UNITED STATES PATENT AND TRADEMARK OFFICE

APPLICATION NO.	FILING DATE	FIRST NAMED INVENTOR	ATTORNEY DOCKET NO.	CONFIRMATION NO.
09/601,545	03/29/2001	Francois Breynaert	60130-865	7785

Office Action Summary	Application No.	Applicant(s)
	09/601,545	BREYNAERT, FRANCOIS
Examiner	Art Unit	
Pedro J. Cuevas	2834

## **DETAILED ACTION**

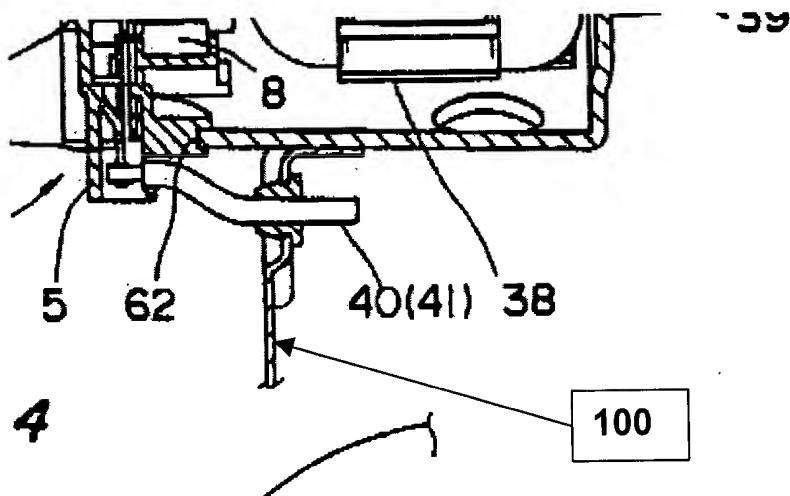
8. Takiguchi clearly teaches the construction of a noise suppression system for a permanent-magnet motor (1), in which:

the motor includes supply brushes (26, 27) connected to an external power supply by leads (40, 41), which are associated with inductors (6, 7);

and a metal casing (5), characterized in that:

each brush is connected to the metal casing of the motor through at least one noise suppression capacitor (8),

in that the metal casing of the motor is connected to the vehicle's earth, and

that the metal casing of the motor and the functional device have complementary

means (100, added by the examiner for convenience) for earthing the casing.
